The north range's back rooms: a way in (the sixth floor, and floors 1 to 7)

The Architect, 15 October 2026, for Godric, on the layout of model version 27 (tools/architect-layout-pdf.py). Godric's question: do pupils walk through the cupboards? No: the layout gives the back rooms no door at all, a gap. One stretch of the sixth floor, x 100.9 to 139.6, at 1:200, north up; red: what is new.

Try 1: a 2.0 m passage through the cupboards to each room

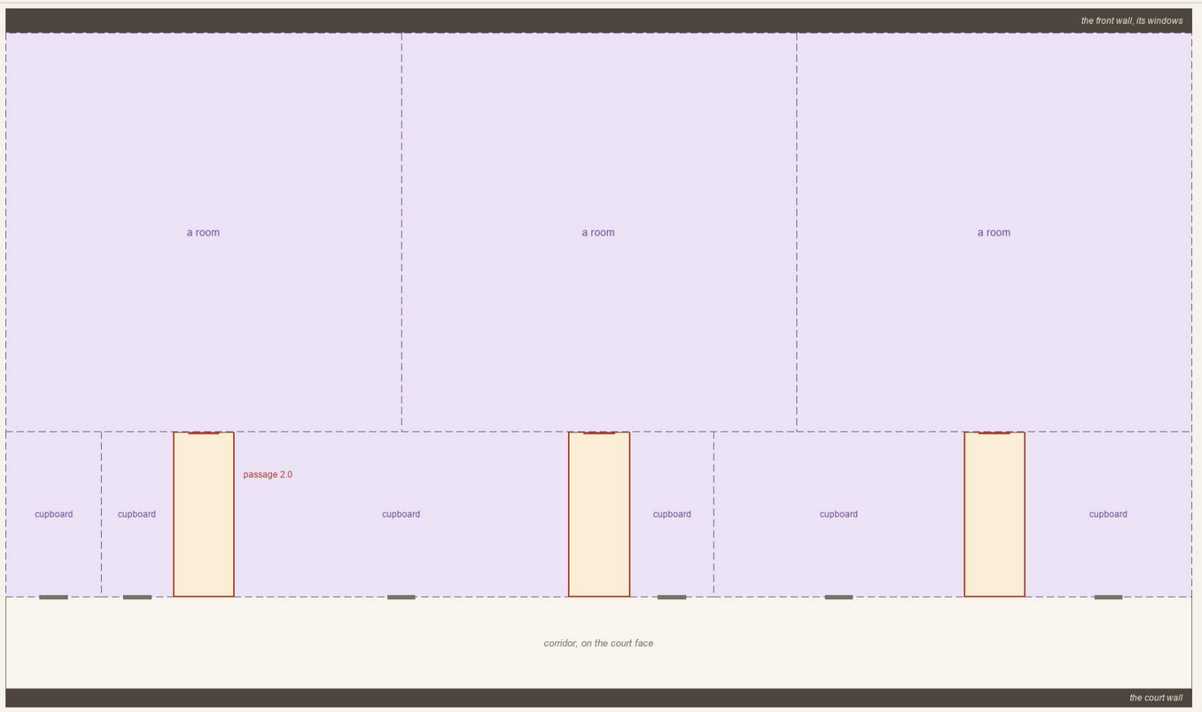
Try 1 recommended: the castle's own way to a room on the front, the model's passages to the Charms and Transfiguration classrooms. Every room keeps its front windows; the cupboards stay where no window reaches, each with its corridor door, 2 m shorter. The stair feet caught the same way (the Astronomy Tower's, the North and West Towers') get theirs too.

recommended

Try 2: the rooms deepened to the corridor, a cupboard built in

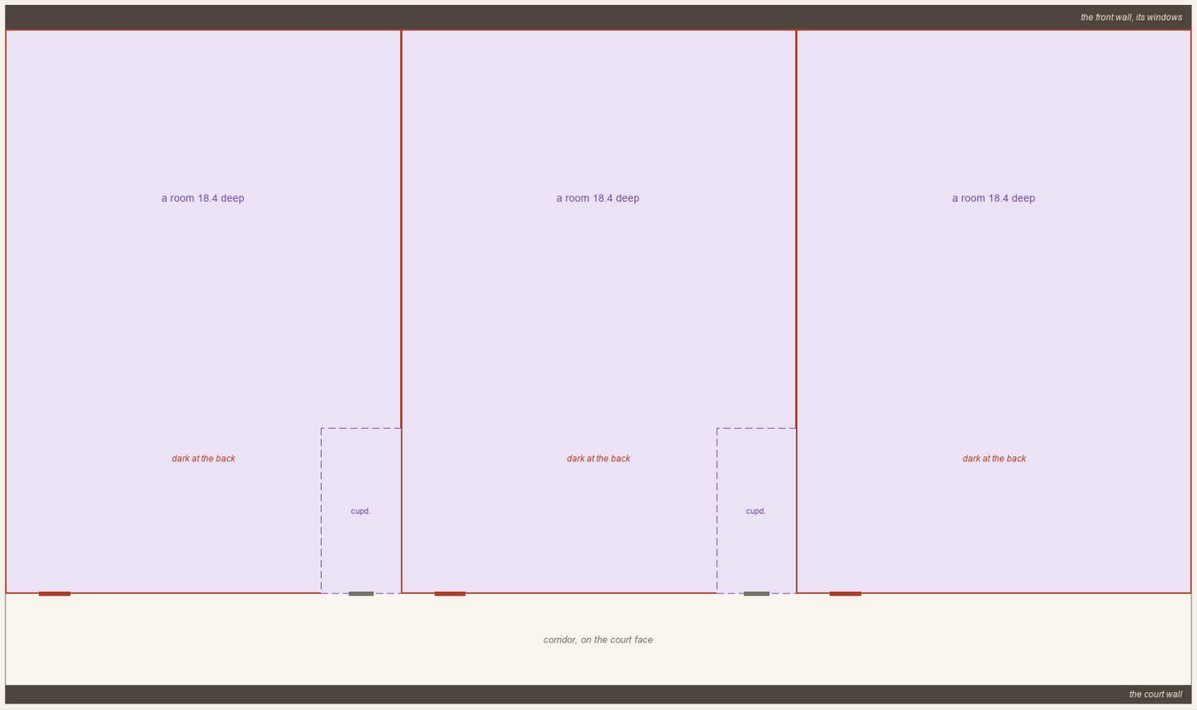
Try 2: rooms 18.4 m deep lit from the front only, the back half dark, and few cupboards. Try 3: a second corridor with no window, the walk doubled, the cupboards 3.4 m deep.
